To: Conseil scolaire Viamonde
Address: 116 Cornelius Parkway
Toronto, Ontario M6L 2K5
Attention: RFP_BAFO #25-03 - CSViamonde
Project Name: Day Care Expansion at École Élémentaire Pierre-elliott-trudeau, 65 rue Grace,
Toronto ON

Addendum No. 1

Project No.: 18113
Date: October 28, 2024
Project: **DAY CARE EXPANSION AT ÉCOLE ÉLÉMENTAIRE
PIERRE-ELLIOTT-TRUDEAU, 65 RUE GRACE, TORONTO ON
Conseil scolaire Viamonde**

DRAWING:
CONSTRUCTION
MANAGEMENT SITE PLAN

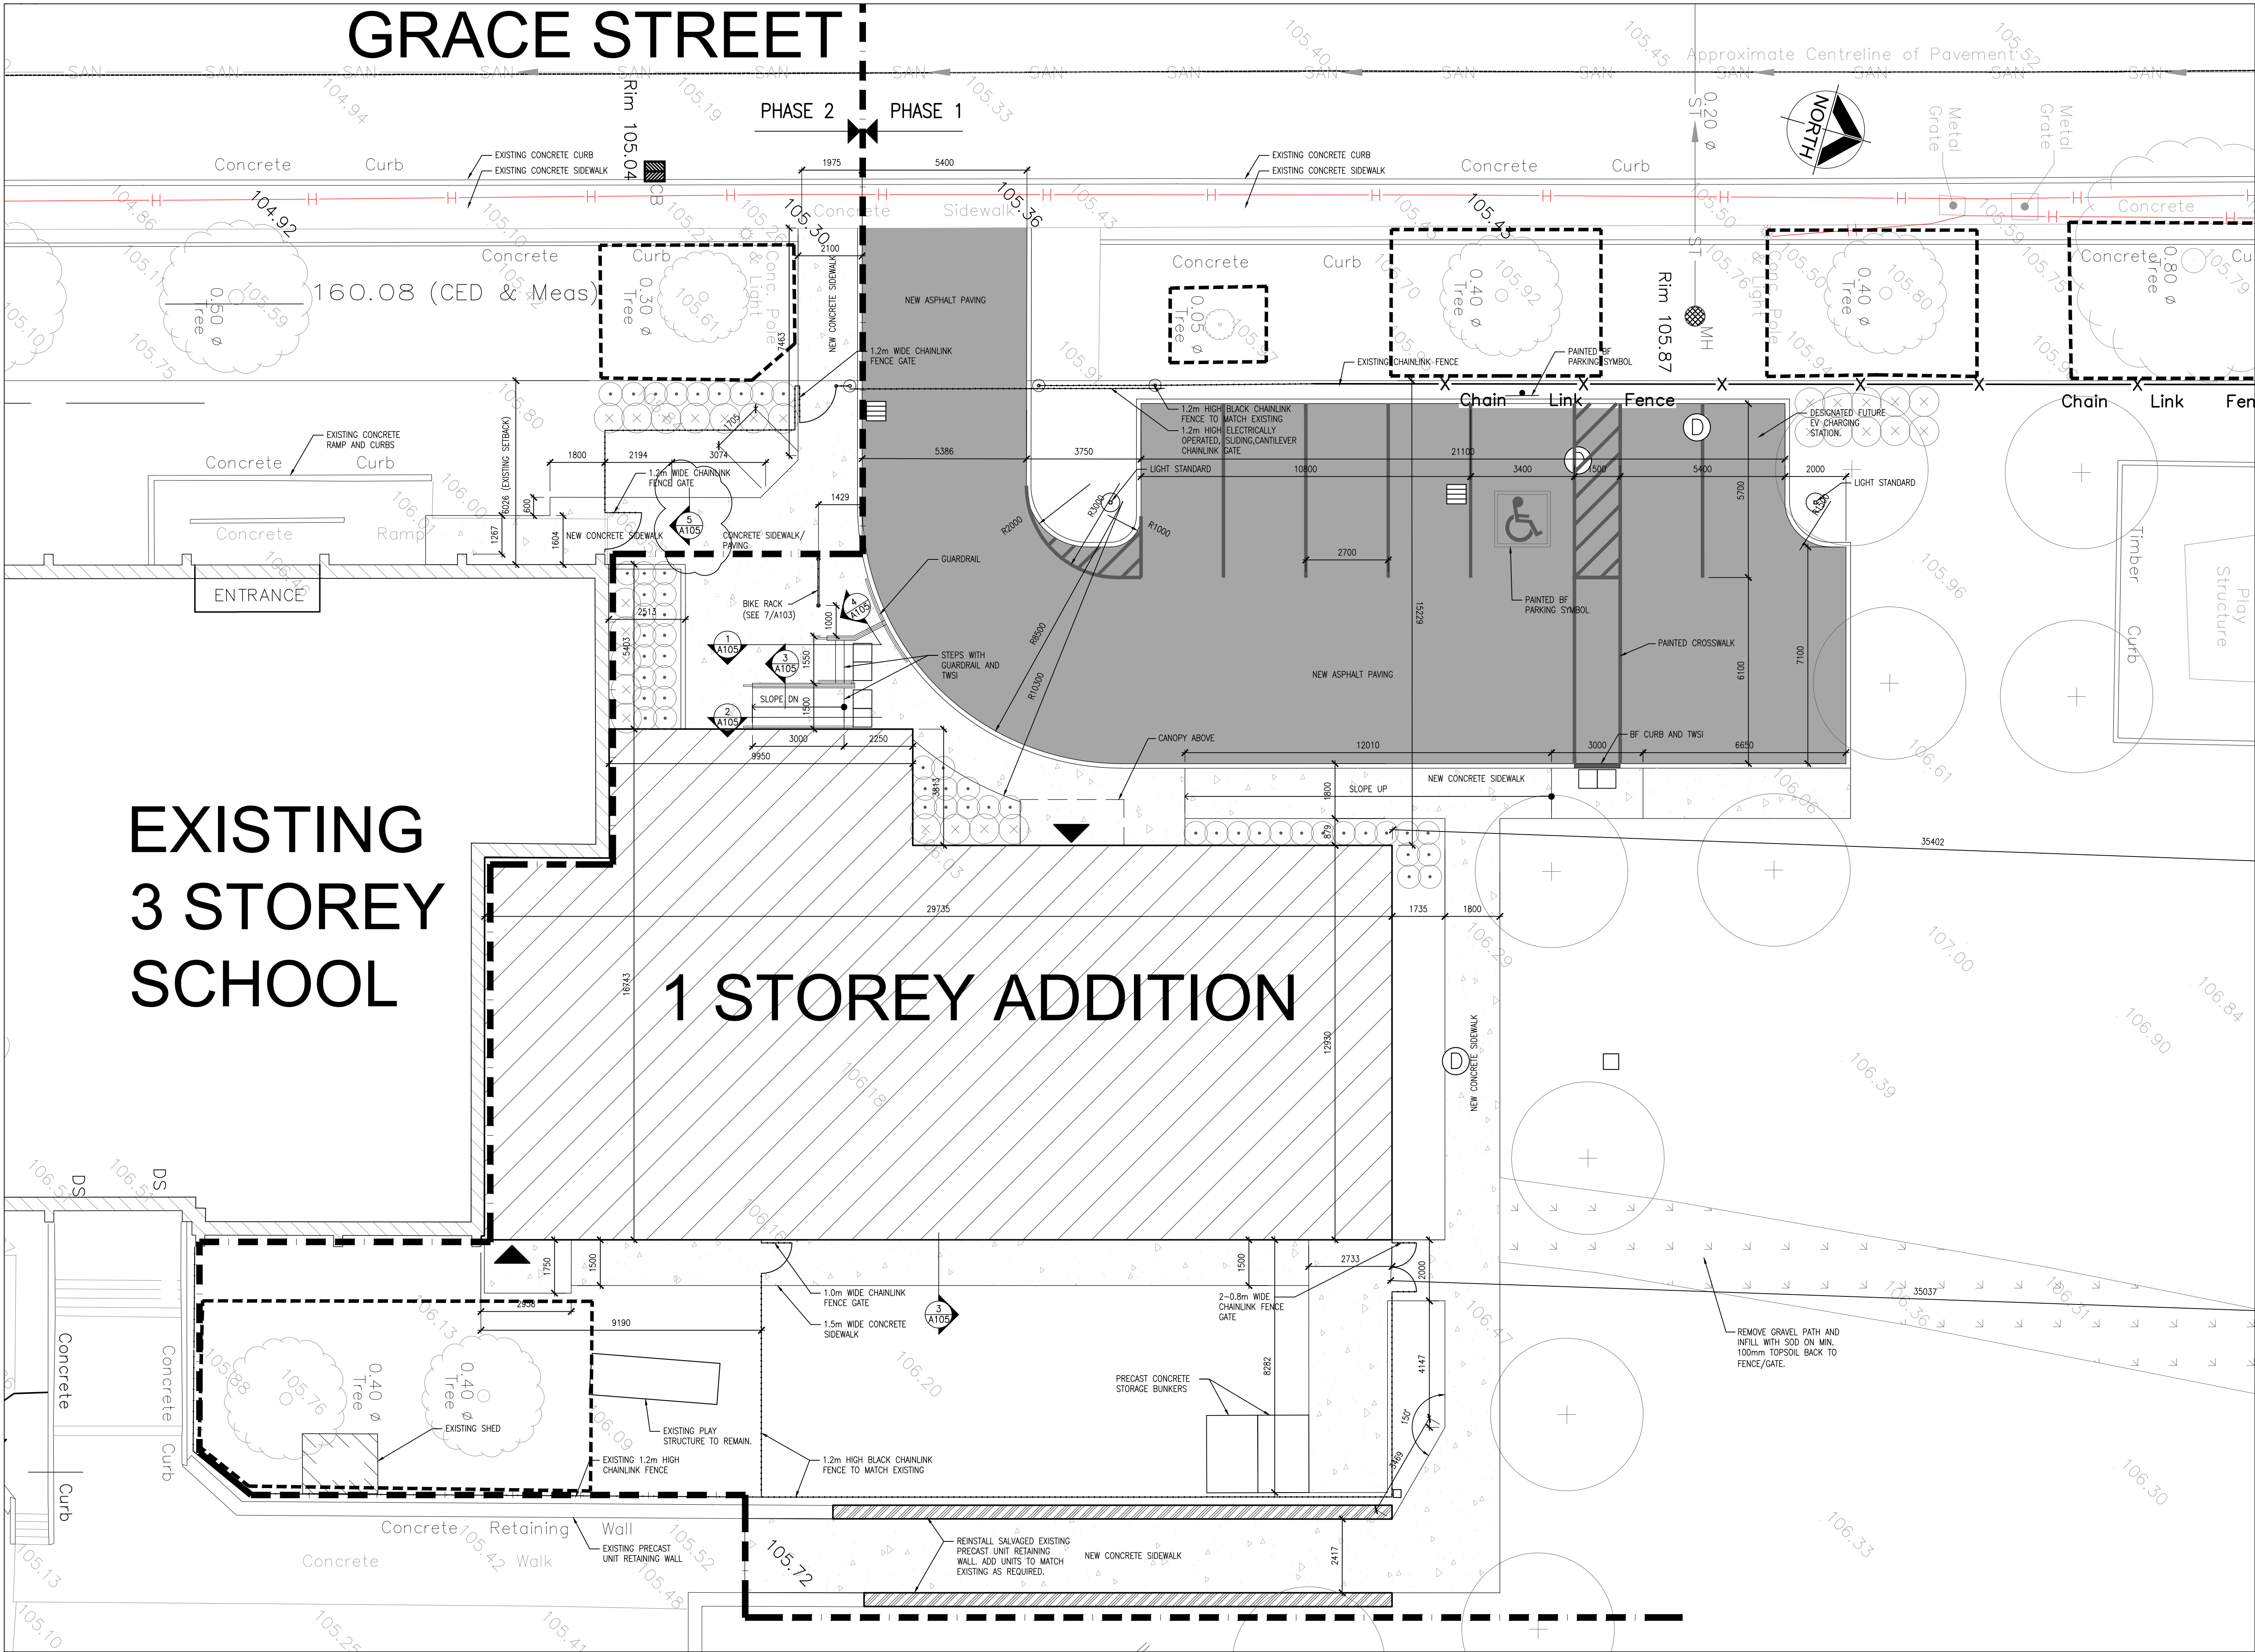
1 .7 DRAWING NO. A101A

- .1 Added this drawing for the construction management plan as required by the City of Toronto. A temp fence exists on the site (where the ground was disturbed for the soil investigation) and can be reused as required for the construction fencing.

6 TEMPORARY CHILDREN'S PLAY AREA
1:100

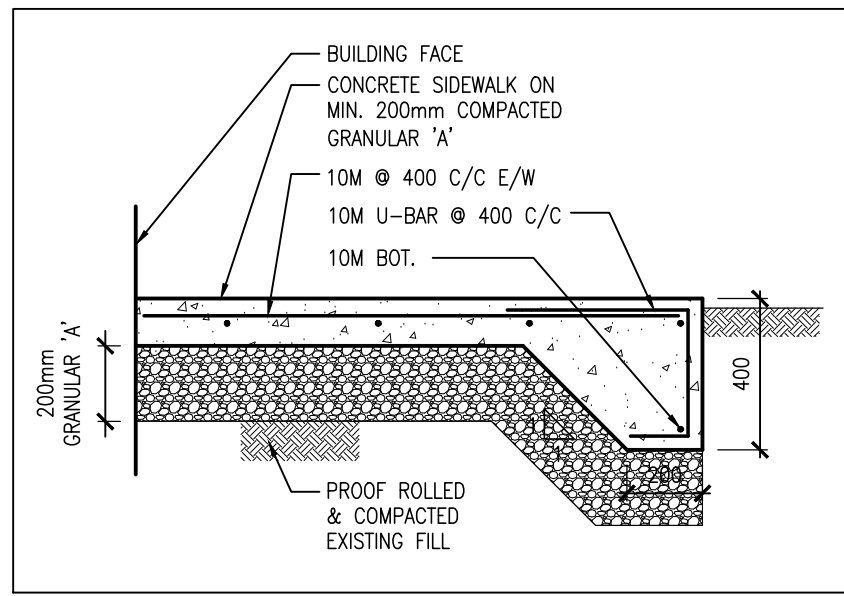
1 .10 DRAWING NO. A105

- .1 Temporary Play Area added to the site plan, plus ramp section 7/A105.

5 TYP. WALKWAY DETAIL
1:20

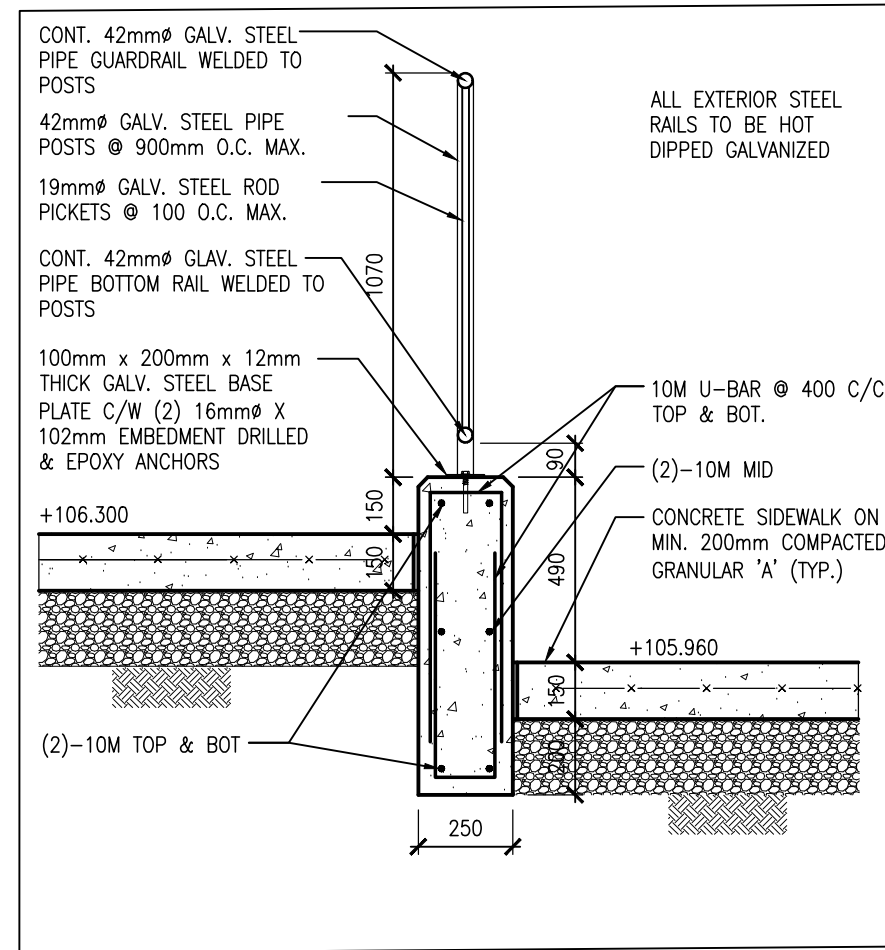
1 .8 DRAWING NO. A102

- .1 Located section detail 5/A105 on the site plan.

- 1 .15 **Question:** Please advise locations where detail 5/A105 is applicable.

Answer: Refer to A102 (part of this addendum) that shows the location (near the entry of the daycare).

7 STAFF ROOM A1-108 INTERIOR ELEVATIONS
A303 1:50

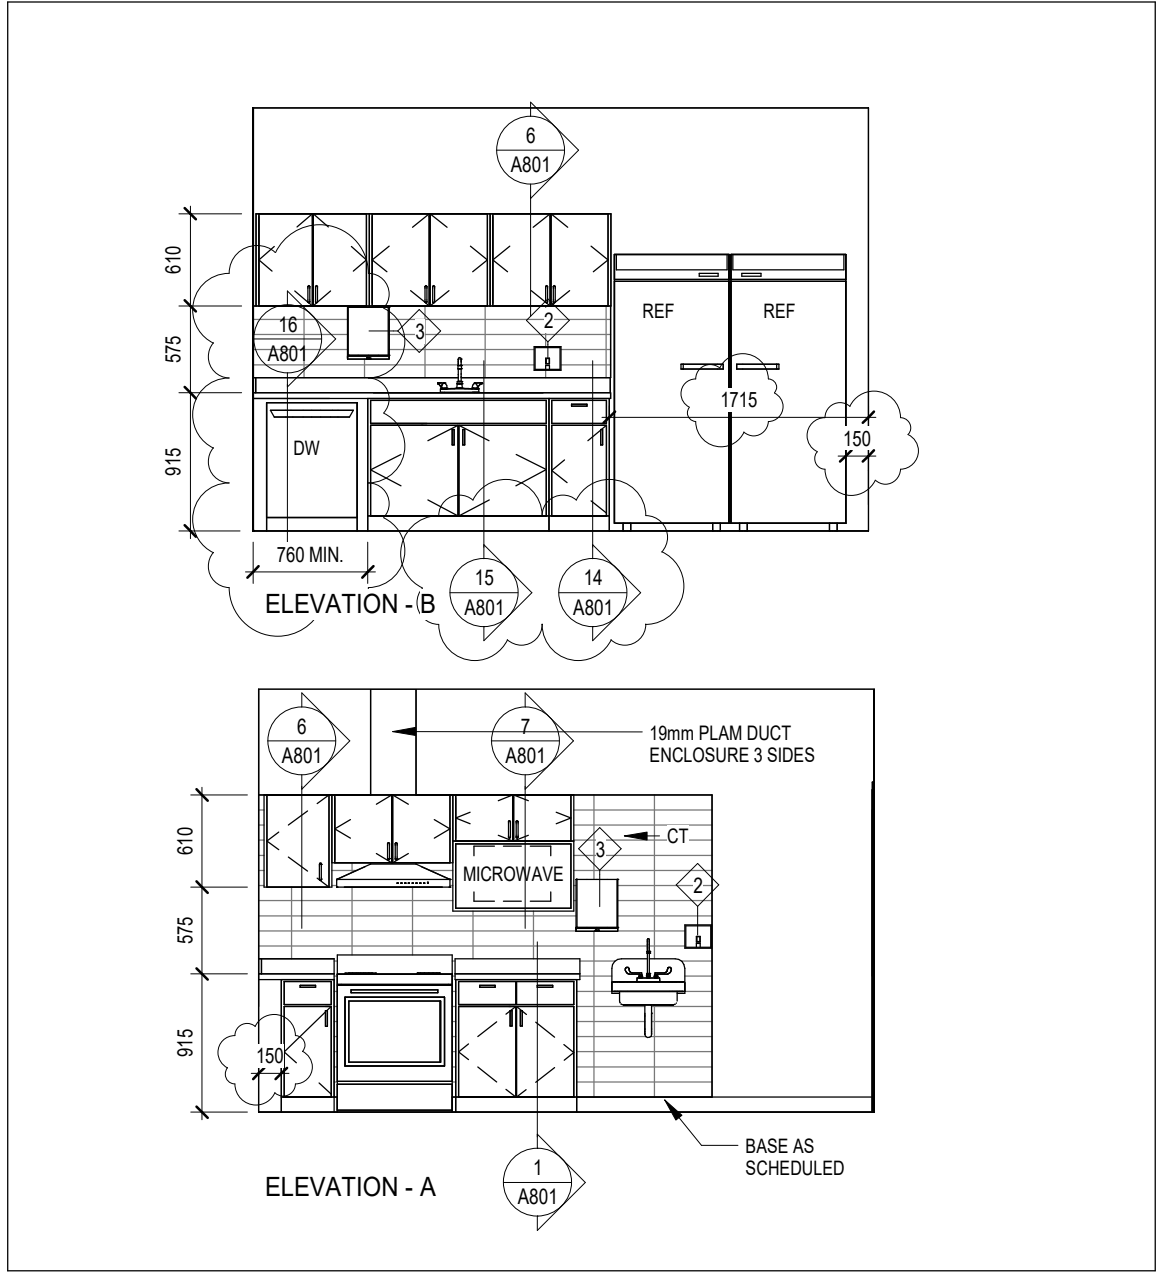
1 .11 DRAWING NO. A303

- .1 Staff Room 7/A303, and Kitchen A1-106 6/A303 modified (to show extra spaces between the wall the adjacent millwork and appliance

6 KITCHEN A1-106 INTERIOR ELEVATIONS
A303 1:50

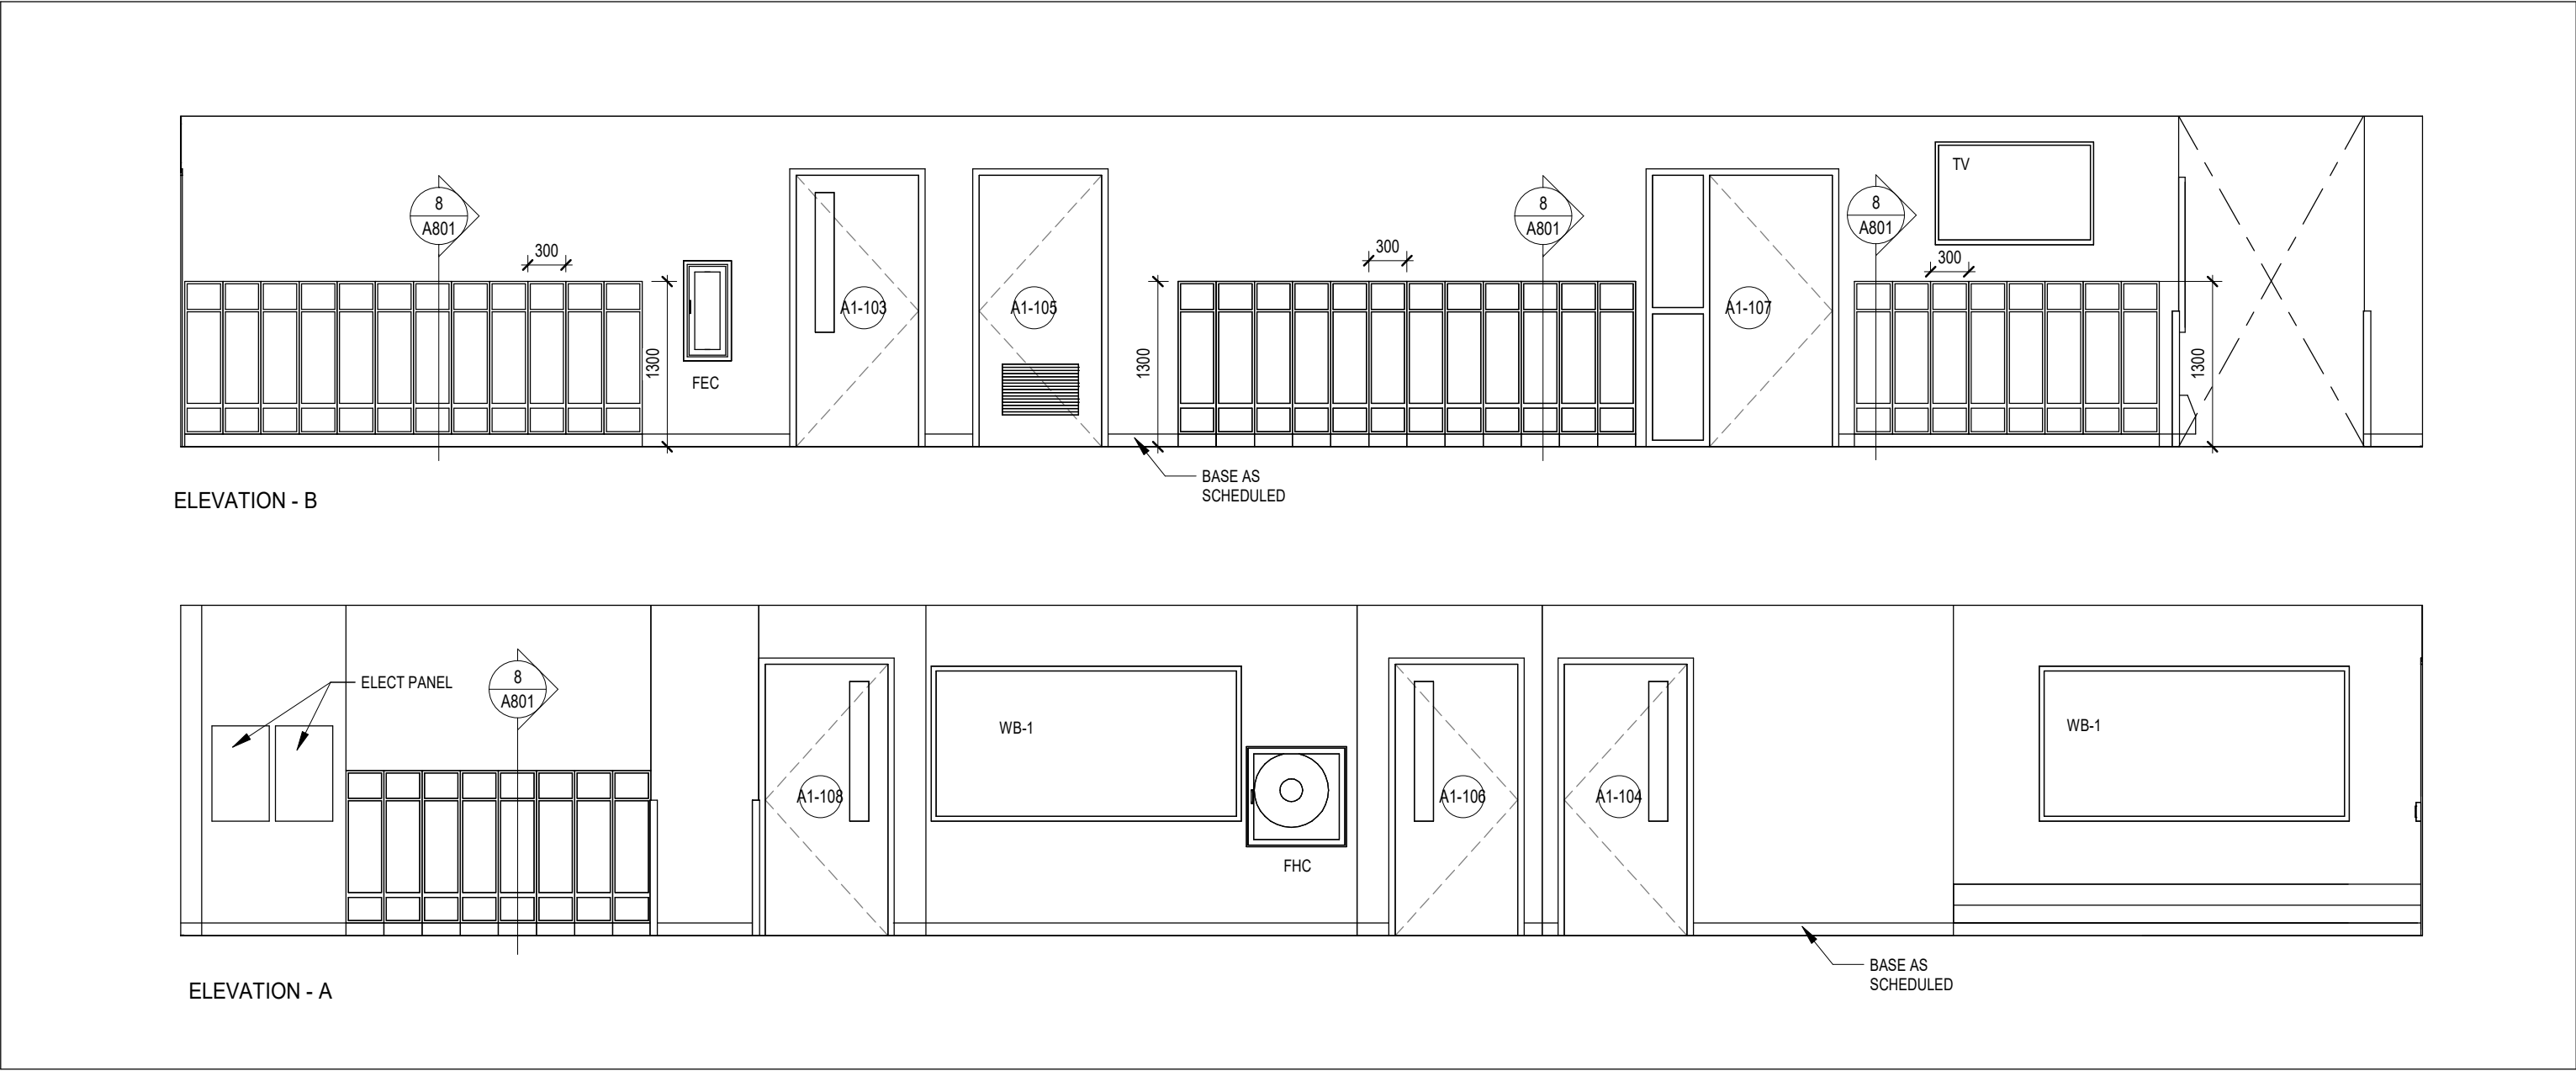
1 .13 DRAWING NO. SK-01

- .1 Provide 150mm space between the wall and the adjacent millwork appliances (to provide clearance for the mechanical baseboard rads).
